[Docket No. FAA–2021–0189; Project Identifier AD–2020–00645–R; Amendment 39–21875; AD 2021–26–16]

Airworthiness Directives; Various Restricted Category Helicopters

ACTION: Final rule.

Figure 1 to the Introductory Text of Paragraph (g)(3) – Main Driveshaft Installation and Removal Tool

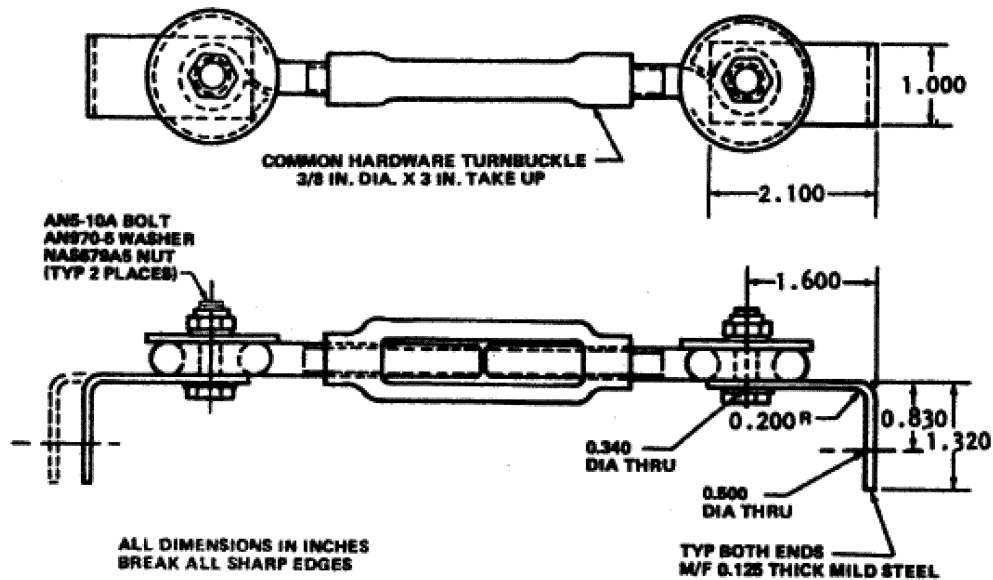
(3) Within 25 hours TIS after the effective date of this AD, remove main driveshaft P/N SKCP2180–1, SKCP2281–1, SKCP2281–1R, or SKCP2281–103 by following “6–24.3. Removal—Main Driveshaft P/N SKCP2281–103” on page 6–24, including “4–24. Removal—Air Inlet Filters” on page 4–17 and “Figure 4–9. Engine Air Inlet Filter Installation” on page 4–16, of Headquarters, Department of the Army, Aviation Unit and Intermediate Maintenance Instructions Army Model UH–1H/V/EH–1H/X Helicopters, Technical Manual TM 55–1520–210–23–1, Change No. 42, dated April 14, 2003 (TM 55–1520–210–23–1 C 42), except where instructed to “refer to figure 6–12.2” in TM 55–1520–210–23–1 C 42, refer to Figure 1 to the introductory text of paragraph (g)(3) of this AD, and where instructed to “see figure 6–12.3” in TM 55–1520–210–23–1 C 42, see Figure 2 to the introductory text of paragraph (g)(3) of this AD, and:

Note 3 to the introductory text of paragraph (g)(3): Figures 6–12.2 and 6–12.3 are missing from TM 55–1520–210–23–1 C 42.

Figure 3 to Paragraph (g)(3)(iv) – Damage Limits

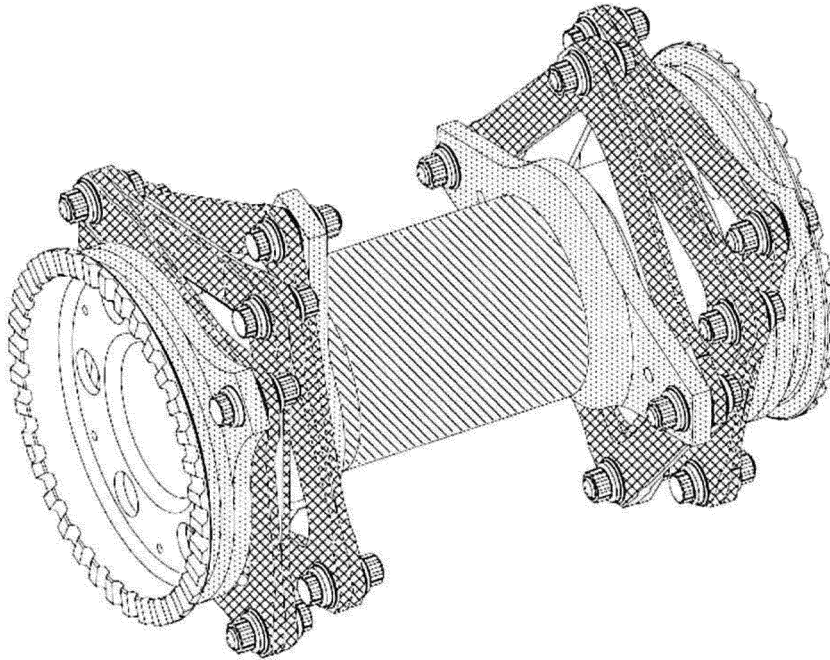
(iv) Inspect the main driveshaft for mechanical damage, corrosion, an edge dent, and nick as shown in Figure 3 to paragraph (g)(3)(iv) of this AD. For the purposes of this inspection, mechanical damage may be indicated by a crack, scratch, or wear; and corrosion may be indicated by corrosion or pitting. If there is a scratch, wear, corrosion, pitting, an edge dent, or a nick within allowable limits, before further flight, repair the main driveshaft in accordance with FAA-approved procedures. If there is a crack, or a scratch, wear, corrosion, pitting, an edge dent, or a nick that exceeds allowable limits,

before further flight, replace the main driveshaft. The main drive shaft may be overhauled in accordance with FAA-

approved procedures to accomplish the replacement required by this paragraph.
